Presentation to the U.S. EPA National Remedy Review Board for the Homestake NPL Site

Ann Maest, PhD
Bluewater Valley Downstream Alliance
25 March 2021

Introduction

Uranium Concentrations, Alluvial Aquifer, 2018

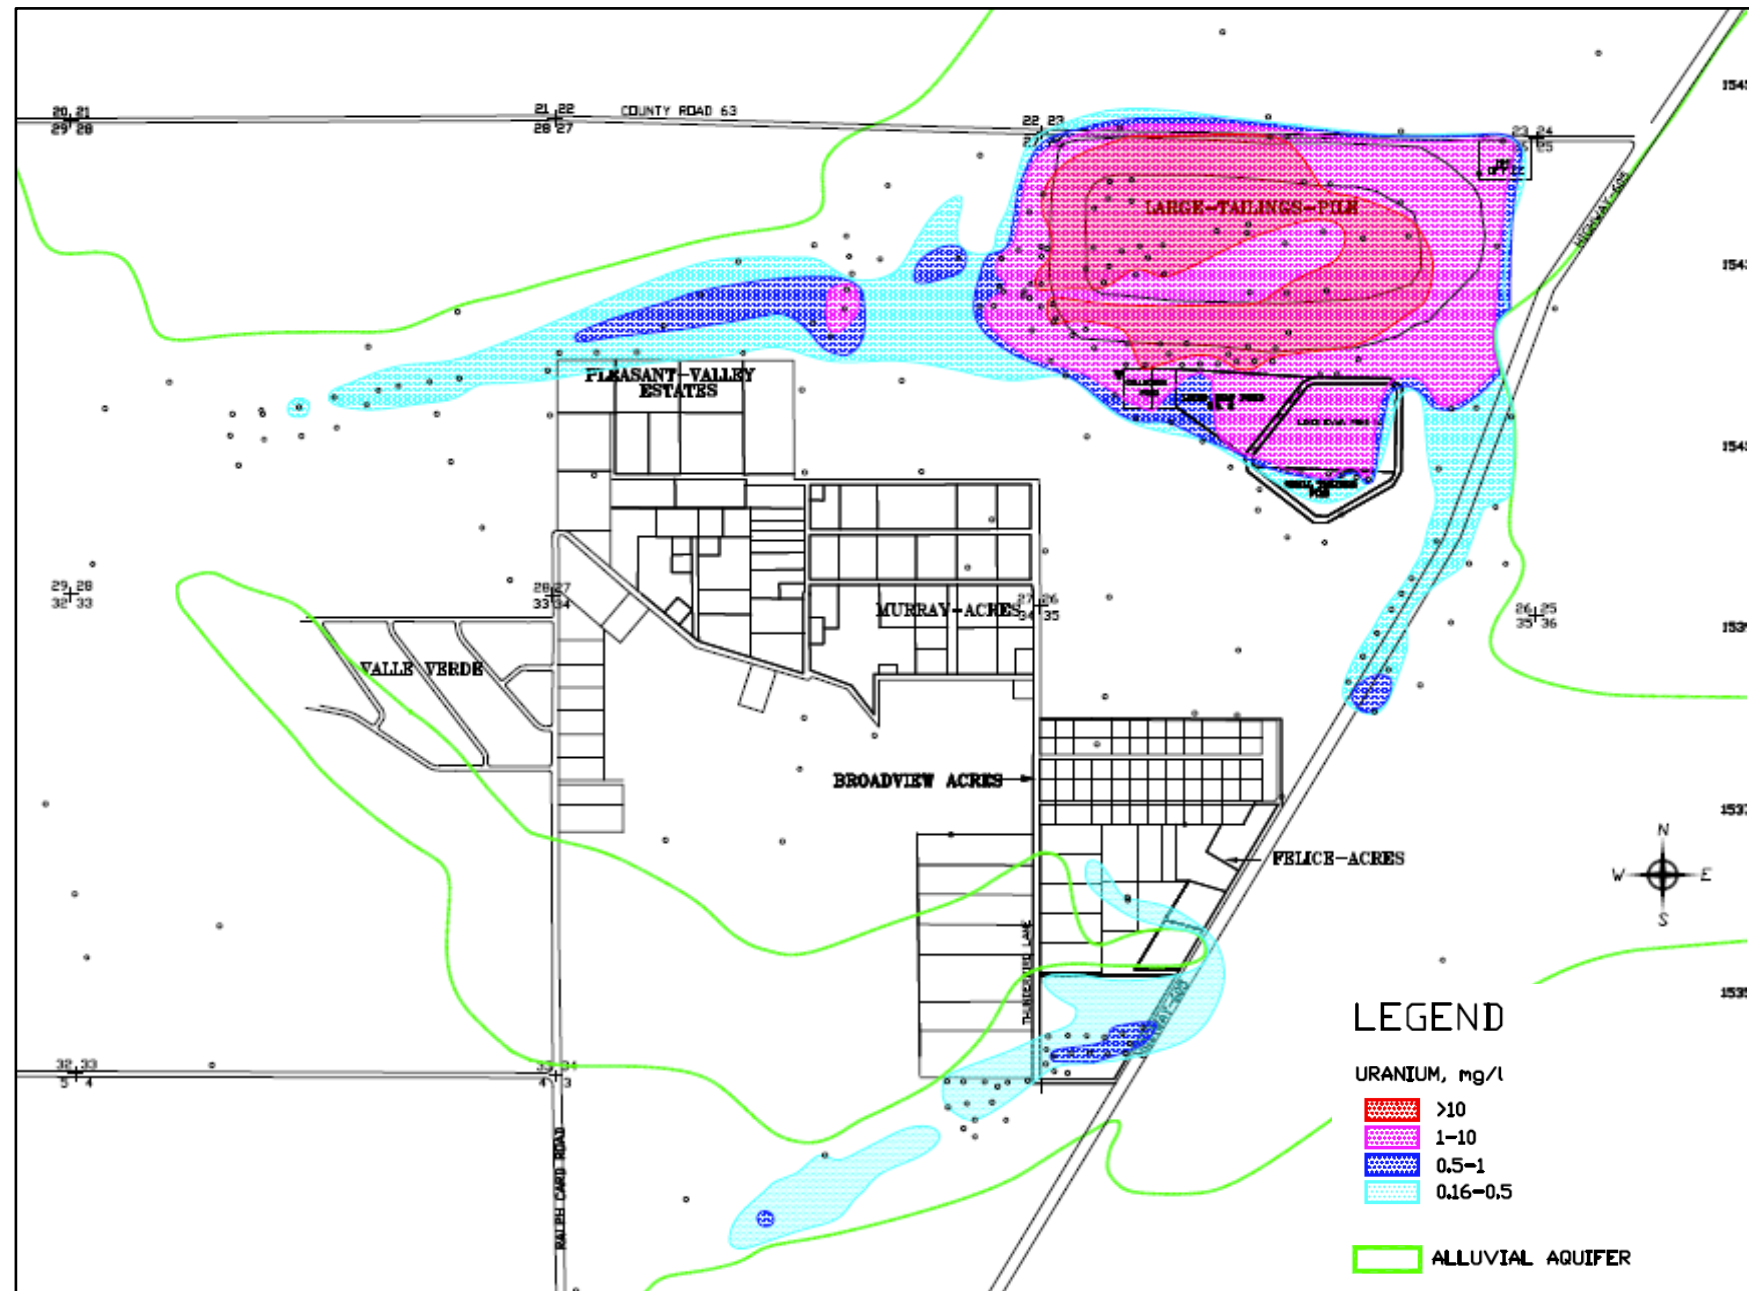
- Preferential pathways for escape of LTP seepage
- U highly mobile; all colored areas exceed site standard

2018 Water Balance: Average Flows

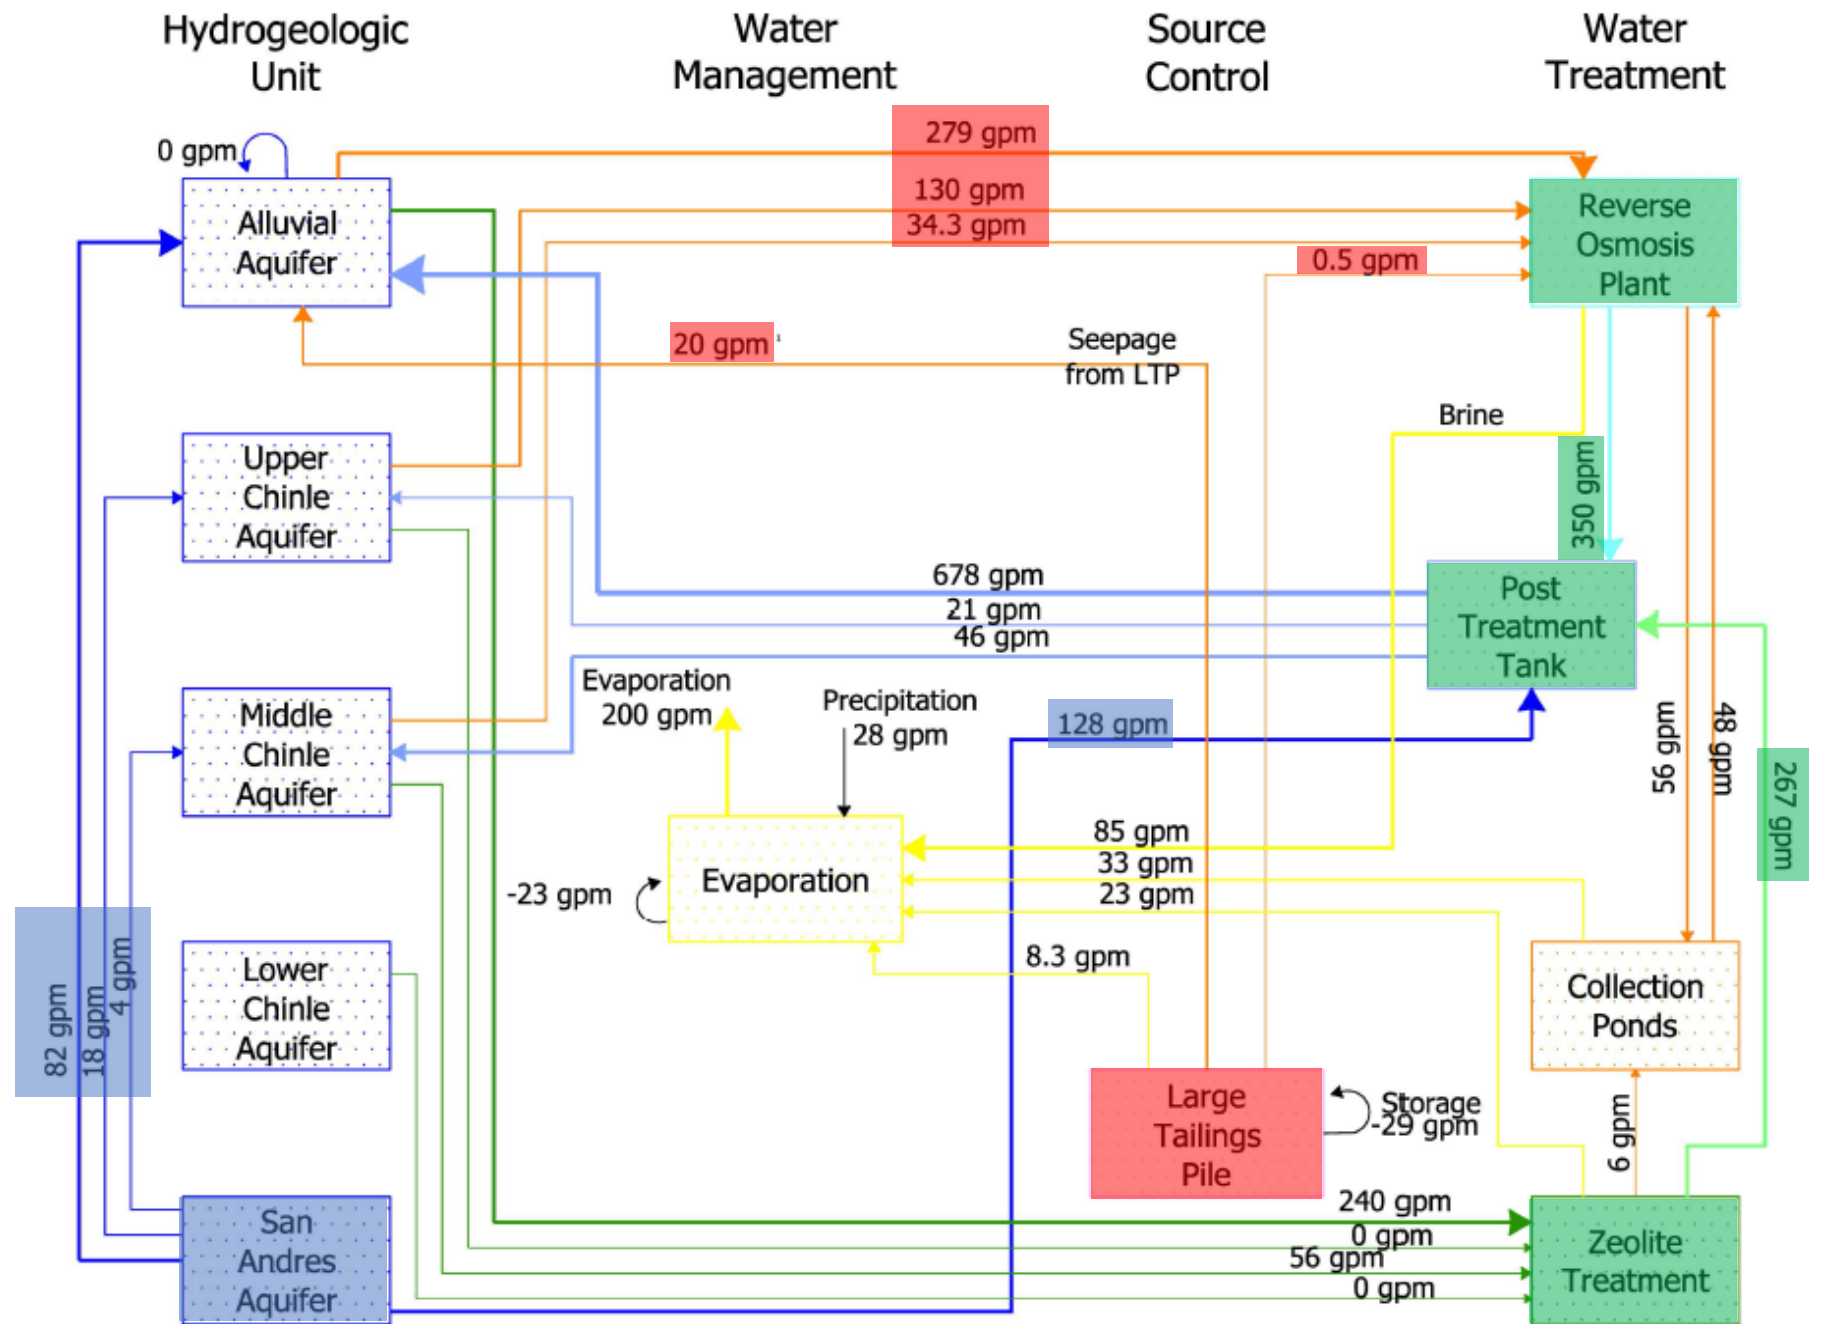
- LTP: 40 times more untreated seepage than treatment

Flawed LTP and Alluvial Aquifer Conceptual Models

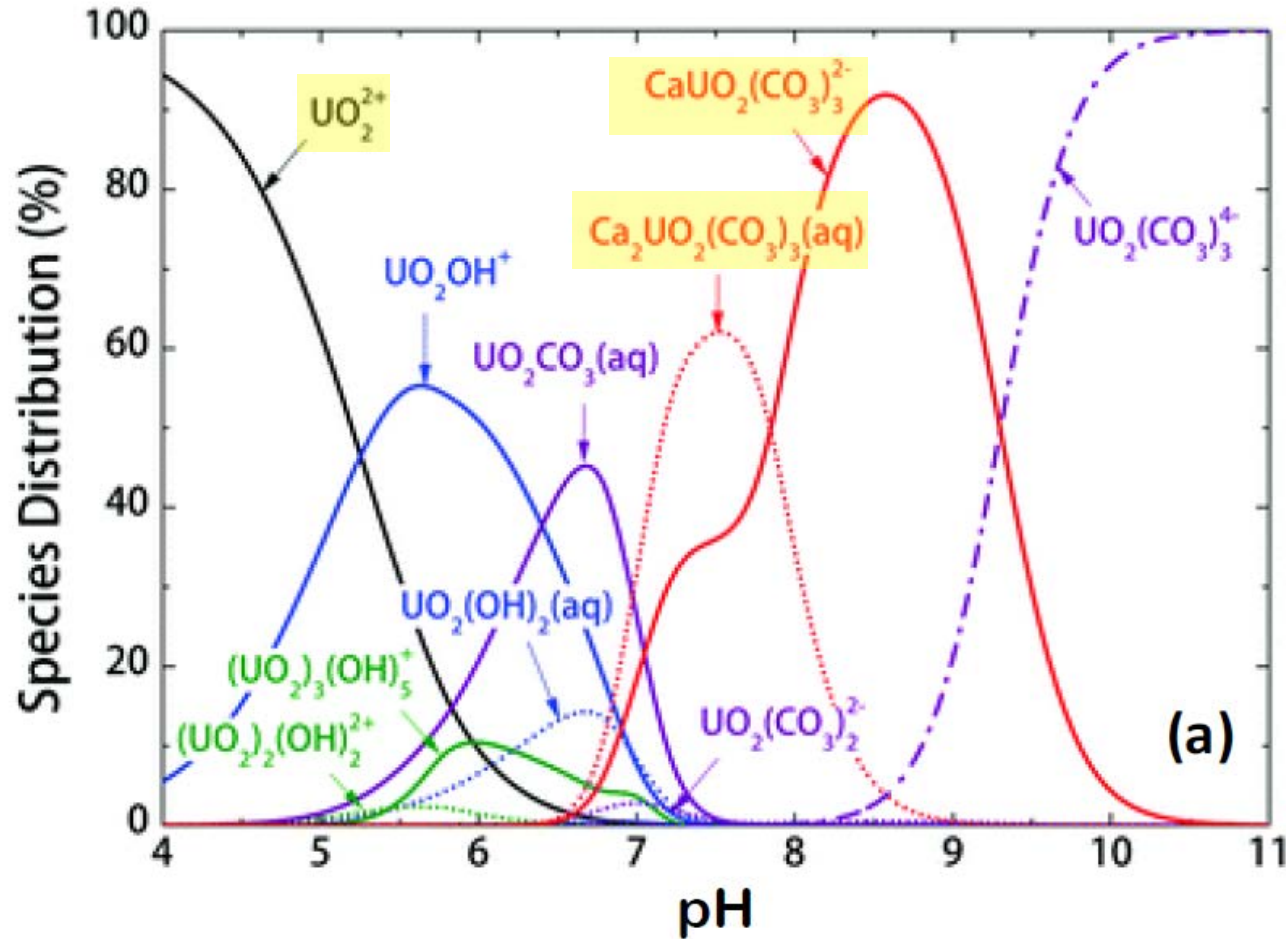
- Conceptual models do not account for
 - Upgradient plumes
 - Contamination of Chinle and SAG aquifers
 - High mobility of U, Se in alluvial aquifer: “natural attenuation” not supported.

HMC’s conceptual models do not provide a “...three-dimensional representation that conveys what is known or suspected about contamination sources, release mechanisms, and the transport and fate of those contaminants” or an adequate or complete description of the “site geology, hydrology, groundwater contamination sources, transport, and fate” required to secure a TI waiver.*

Sample results selected for Current GWPS Show Mining Influence

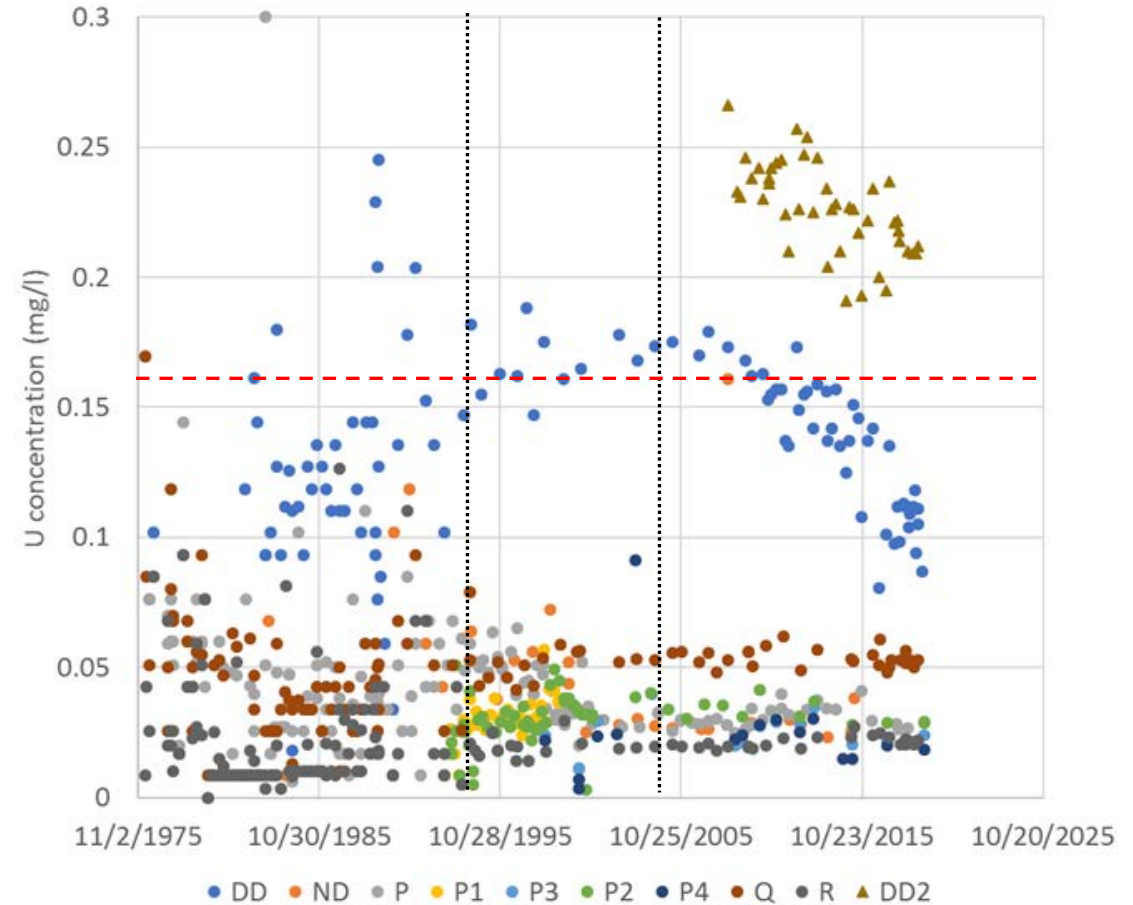
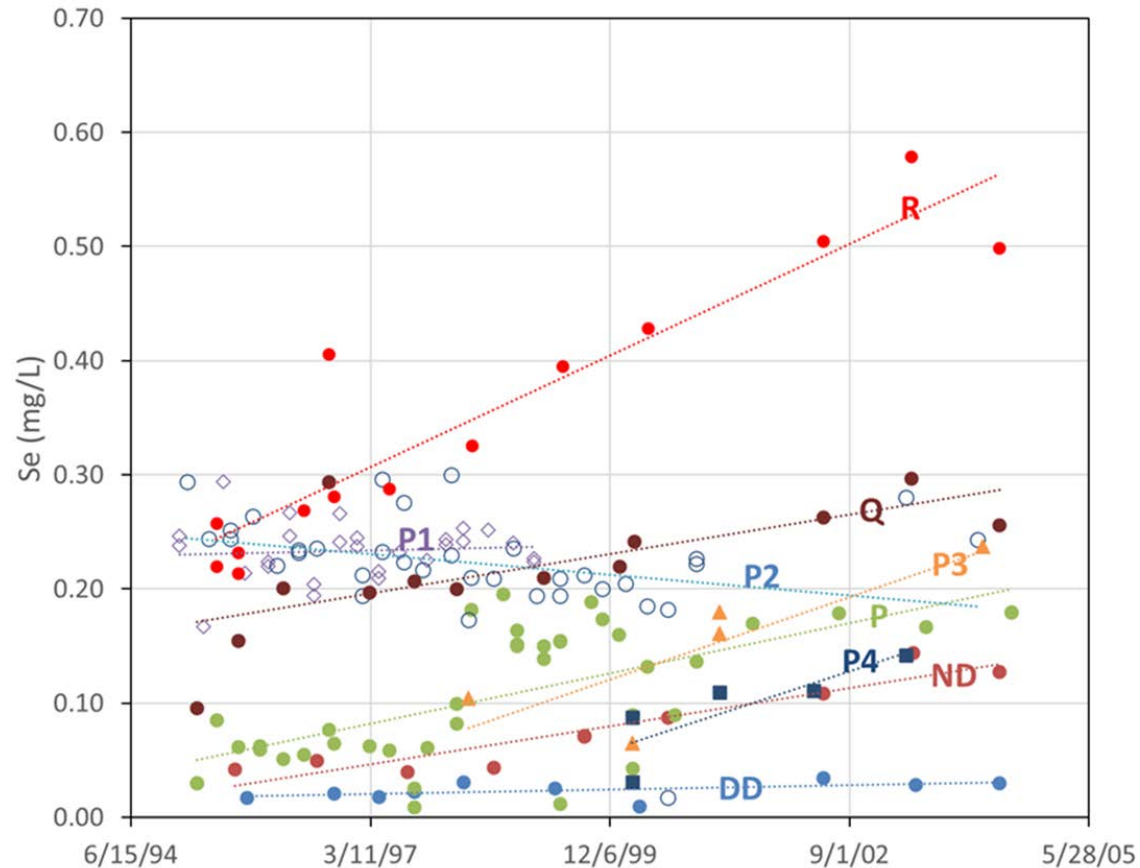
- Current GWPS used alluvial wells DD, ND, P, P1, P2, P3, P4, Q, and R
- 1995-2004; approx. date range and current GWPS shown
- Well DD should be excluded for U GWPS
